COMPANY:		VSUN	
TITLE:		V5501	
CODE:	SIZE:	DRAWING NO:	REV:
CODE	A1	Drawing Number	P1
SCALE: <Scale>		SHEET: 48	12

COMPANY: VSUN			
TITLE: V5501			
DRAWN: YLW	DATED: 2016/03/18	CODE:	SIZE: A1
CHECKED: <Checked By>	DATED: <Checked Date>	DRAWING NO:	REV: P1
QUALITY CONTROL: <QC By>	DATED: <QC Date>	SCALE: <Scale>	SHEET: 6F 12
RELEASED: <Released By>	DATED: <Release Date>

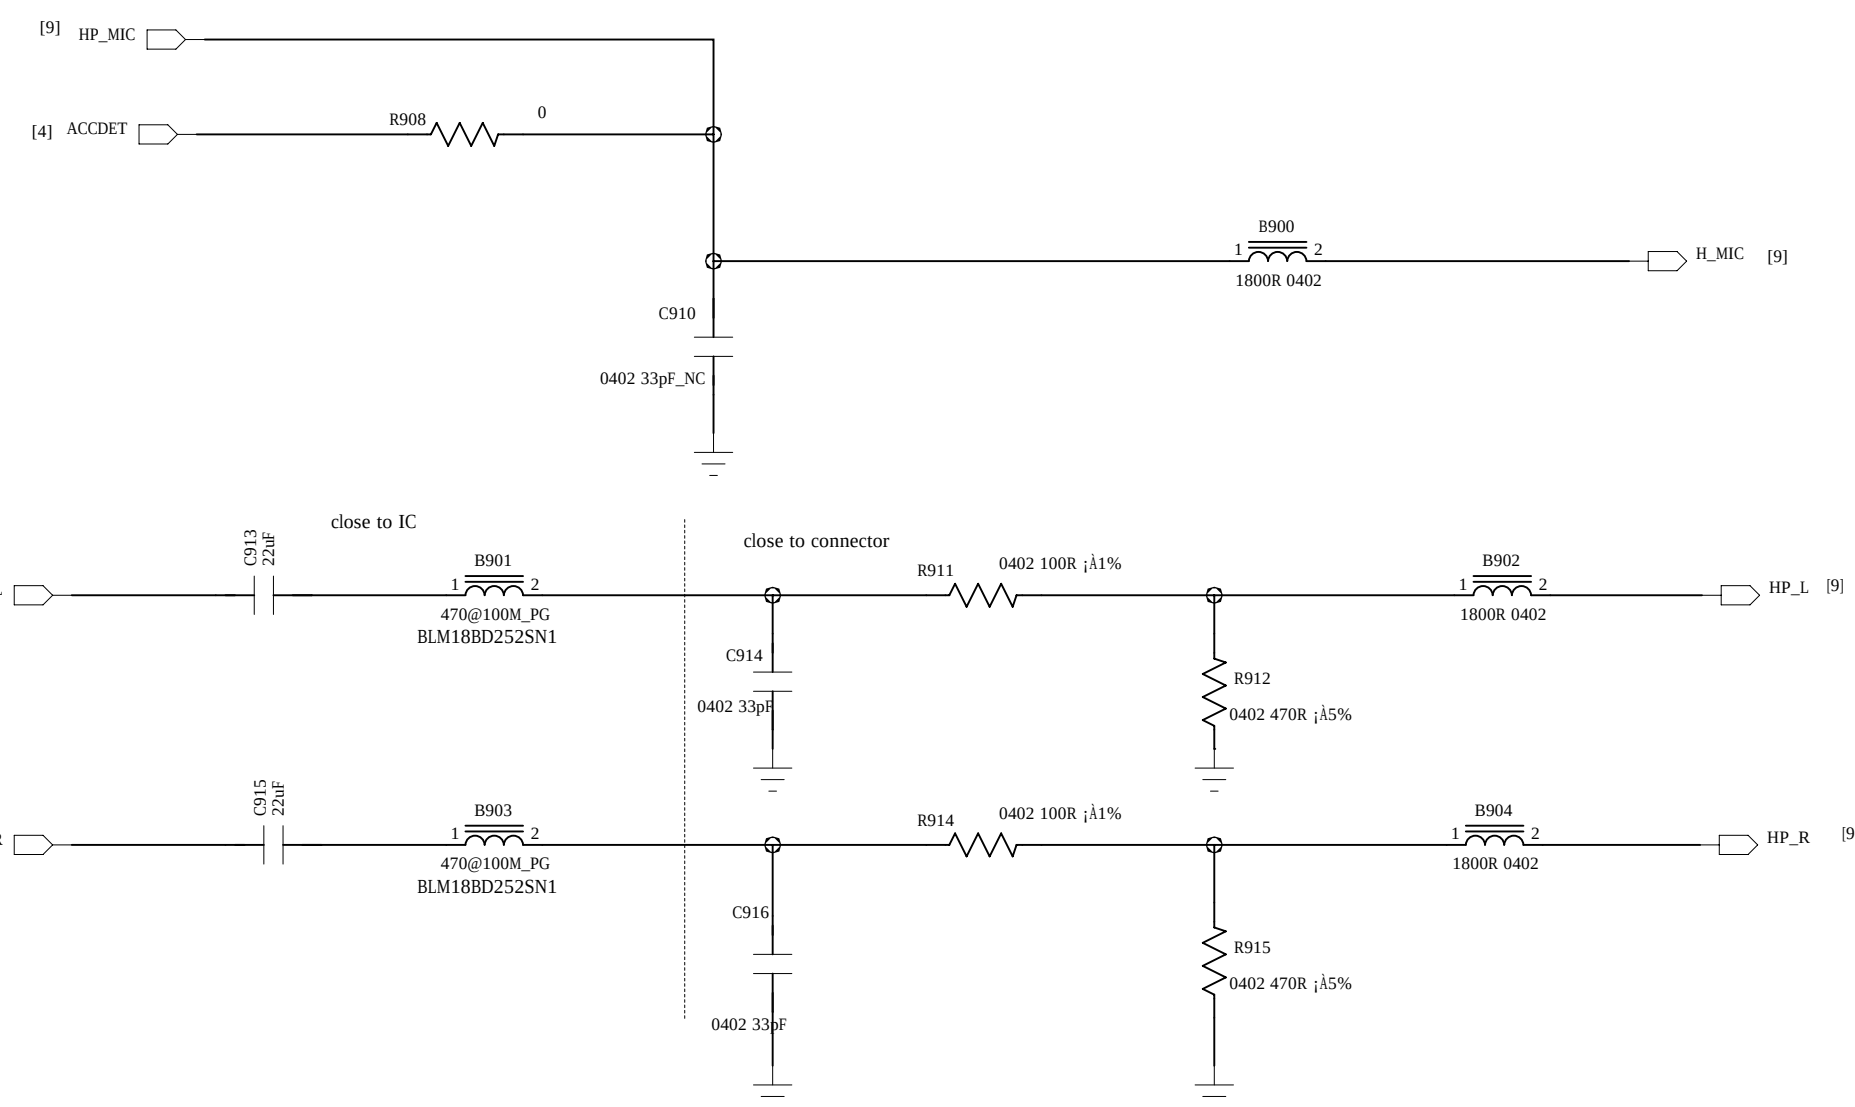
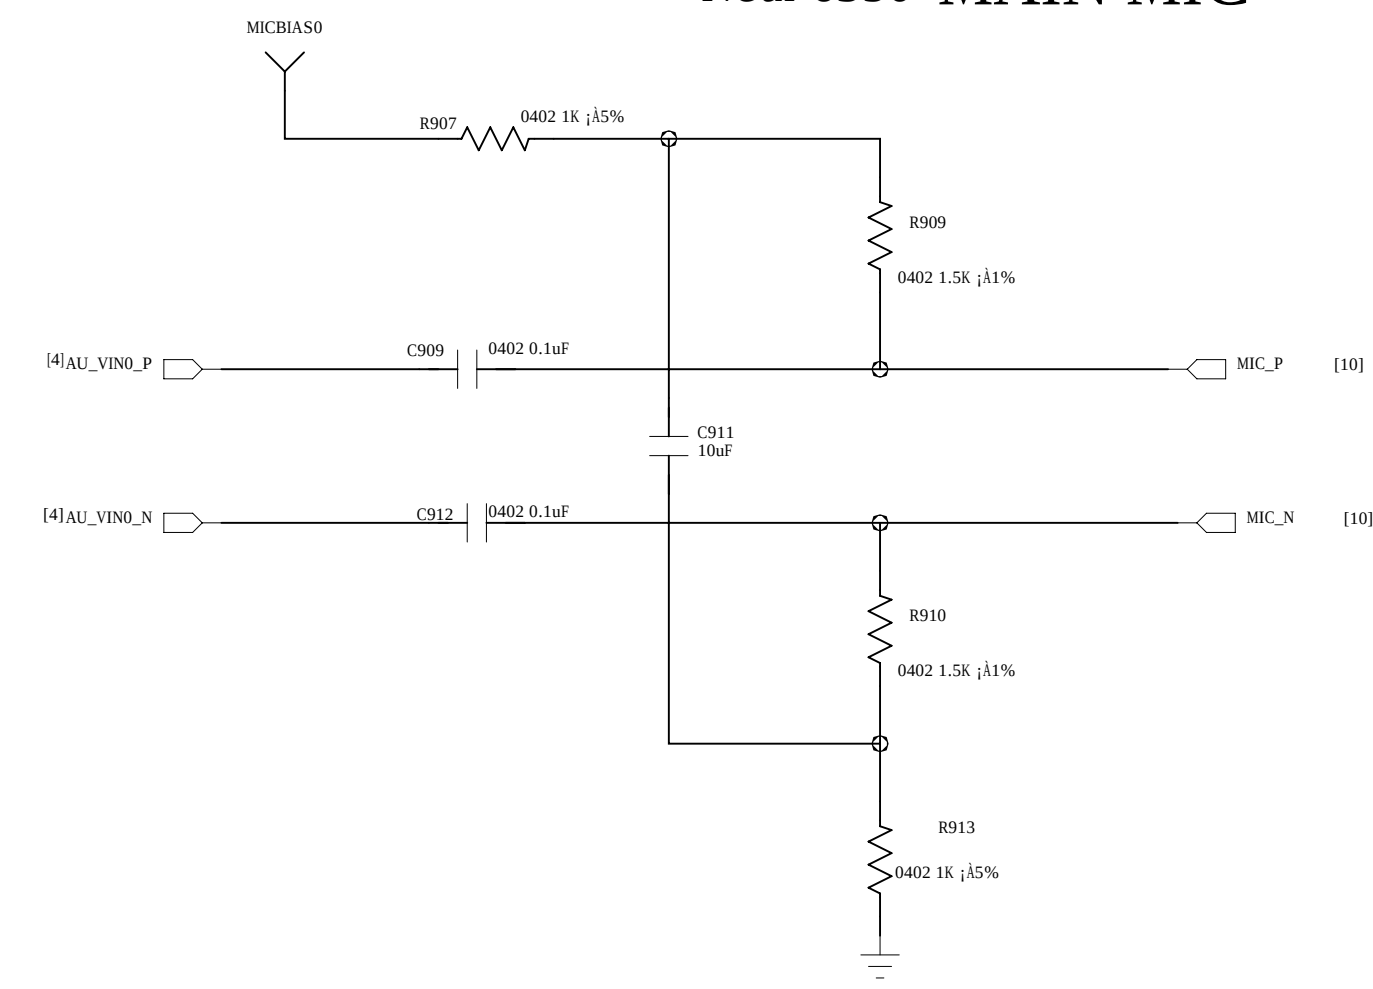
Earphone MICPHONE

Near 6350 MAIN MIC

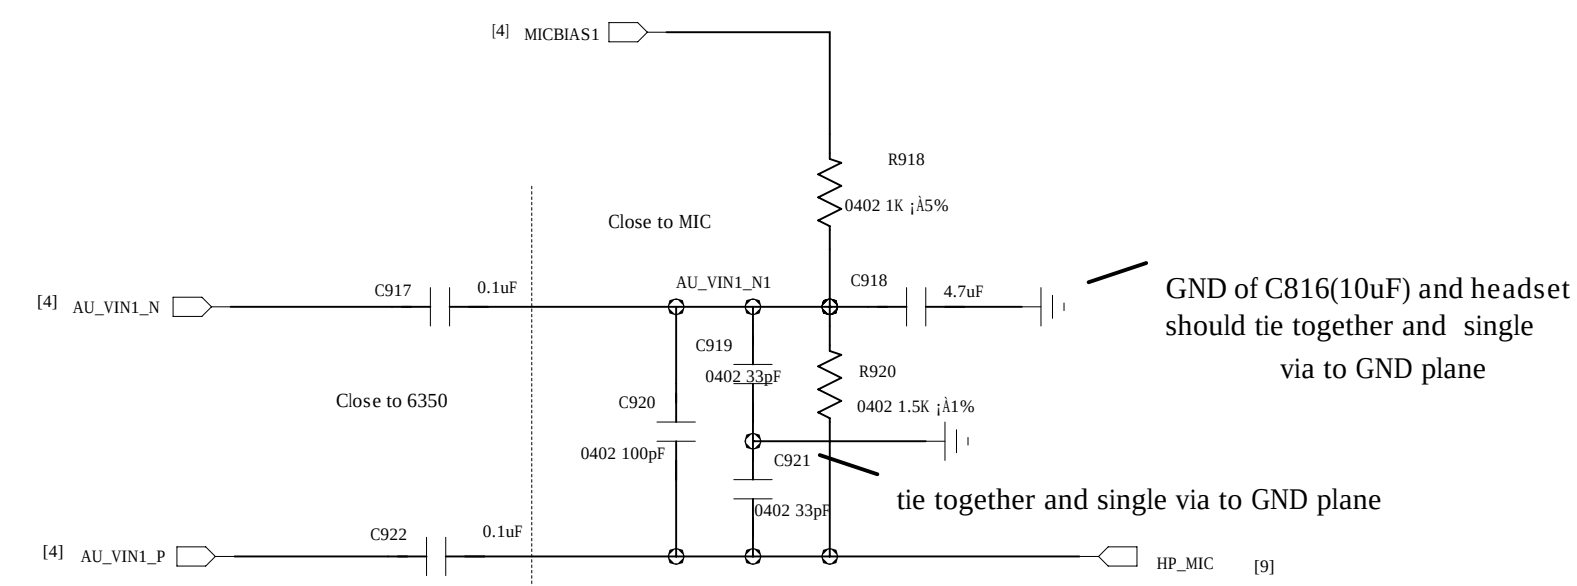
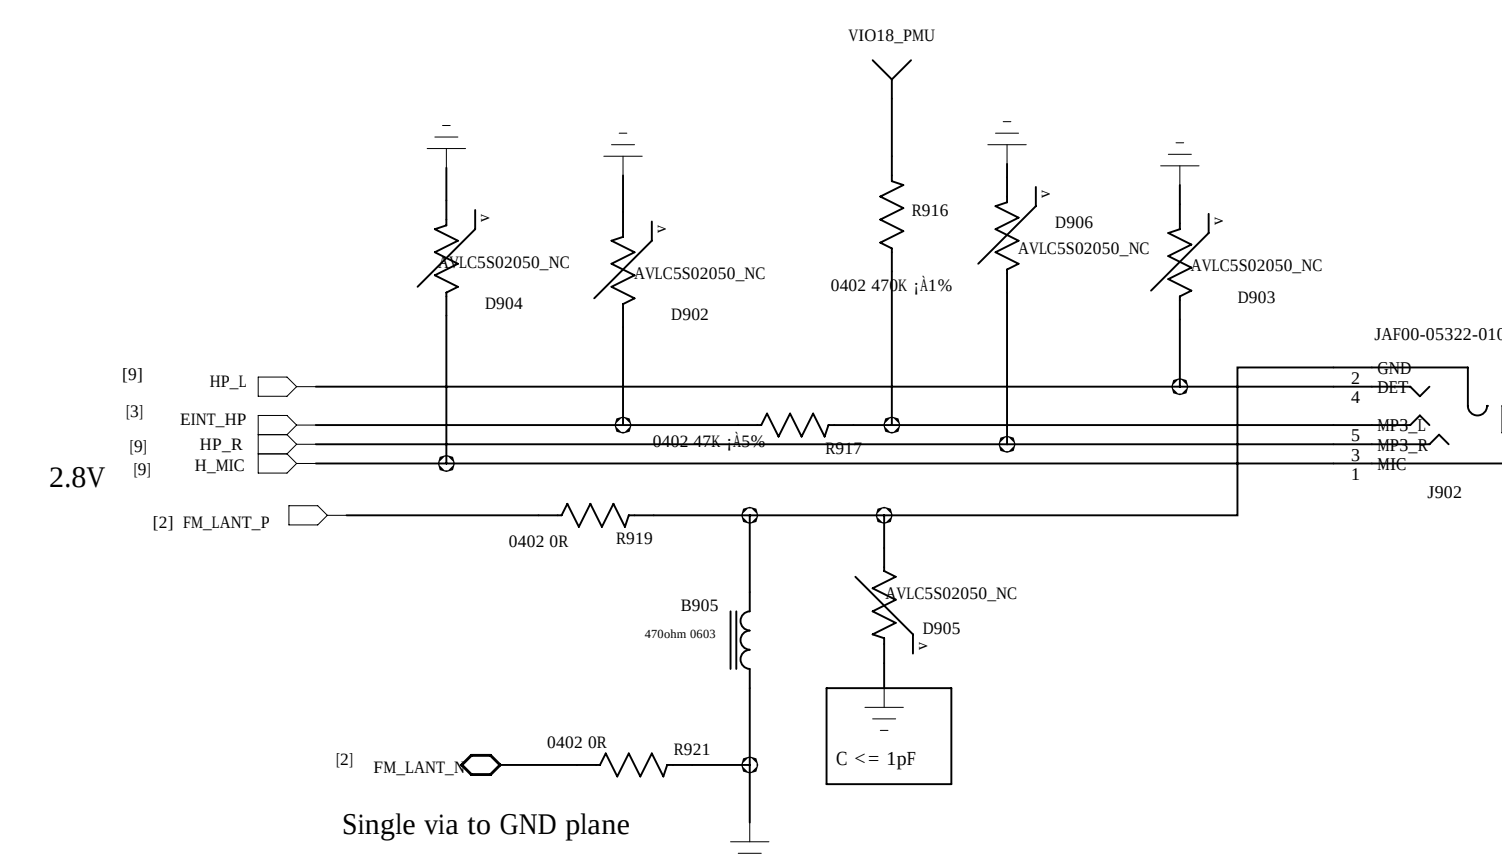
GND of C816(10uF) and headset
should tie together and single
via to GND plane

tie together and single via to GND plane

Same power domain to EARPHONE_DET
